1964 - 1966 Corvette: Service Bulletin: Gear Shift Control Assembly Buzz

Subject: Gear Shift Control Assembly Buzz

Bulletin No: TSB #66-65

Date: June 13, 1966

FIGURE 1

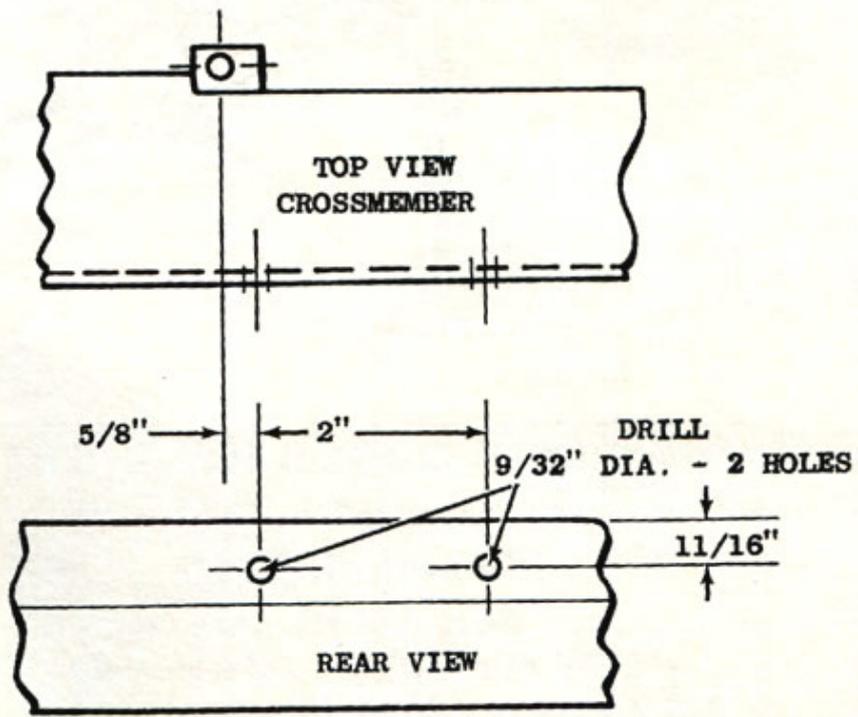
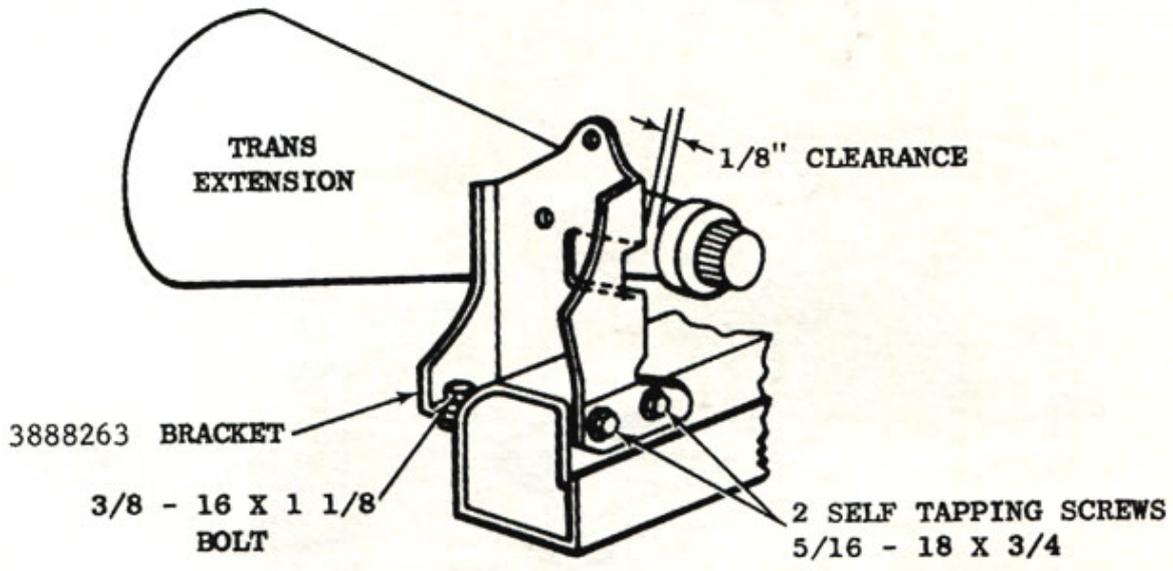
7. Scribe a line 11/16" down from top surface of crossmember on rear side (See fig. 1.)
8. Move new bracket, Part No. 3888263, into position from rear of crossmember.

9. Loosely install bolt through front leg of new bracket through mounting tab on front of crossmember (center in slot). (See fig. 2, item 6.)
10. Using bracket as template, locate position of holes to be drilled at center of bracket slots. (fig. 1)

11. Remove bracket and drill two 9/32" holes in rear of crossmember. (See fig. 1.)
12. Loosely install new bracket using two 5/16" self-tapping screws and washers at rear attachment. (See fig. 2, items 4 and 5.)

15. Reinstall transmission mounting assembly and bracket and exhaust support. Tighten all bolts securely with exception of bolt holding new bracket.
16. Adjust new bracket laterally to provide desired 1/8"* clearance between transmission extension and bracket, then tighten bracket

screws securely. (See fig. 1.)

* Clearance in excess of 1/8" may cause binding in reverse operation.

FIGURE 2

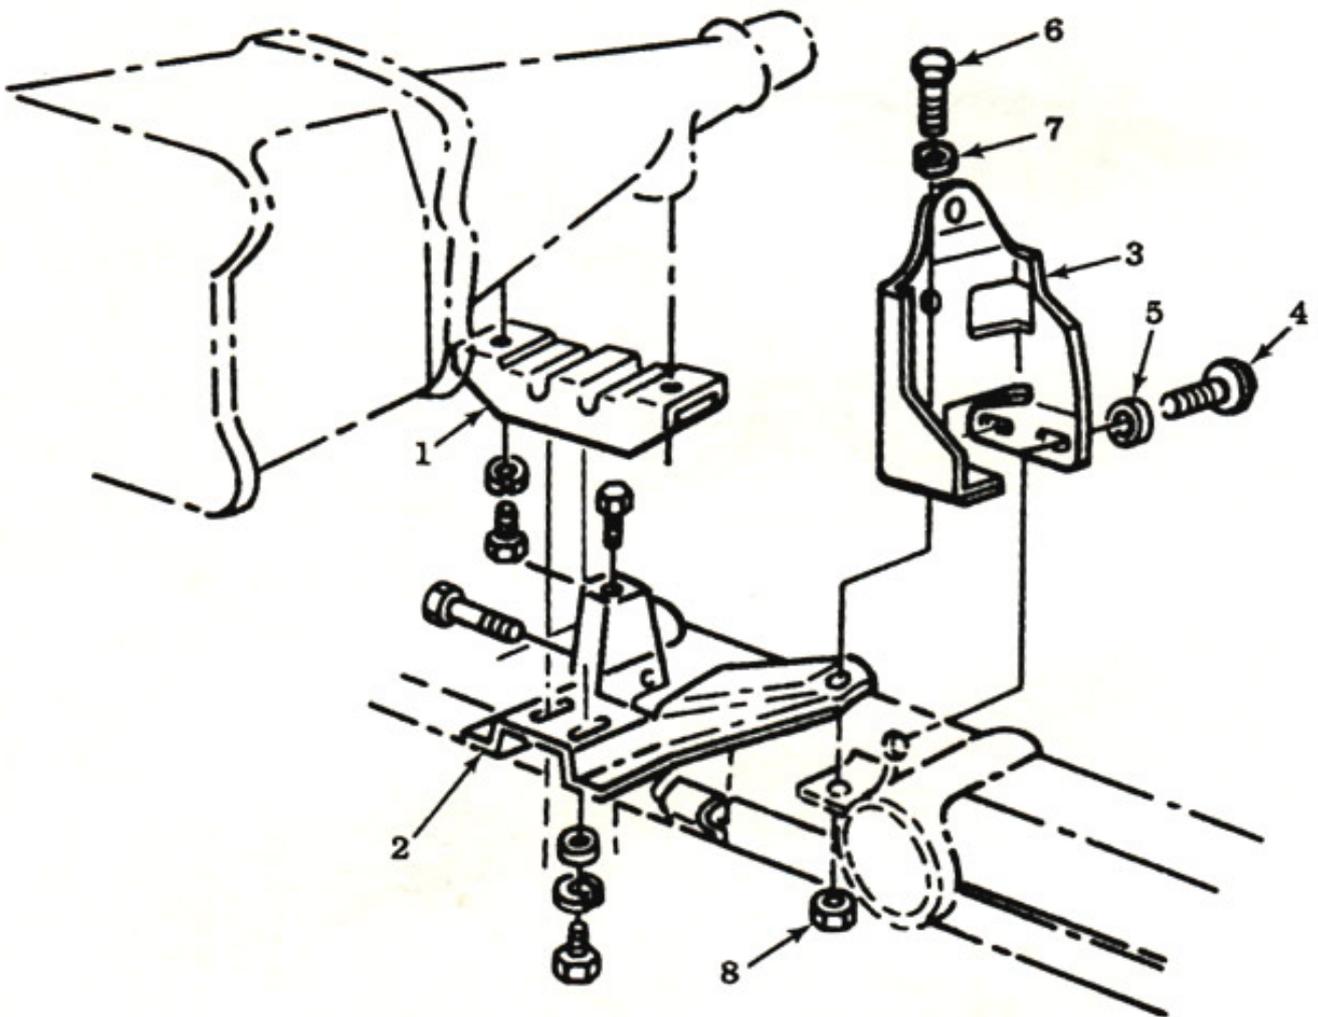
1. Remove shift levers at transmission.
2. Position jack stand under transmission and remove transmission mounting assembly and bracket. (See fig. 2, items 1 and 2.)
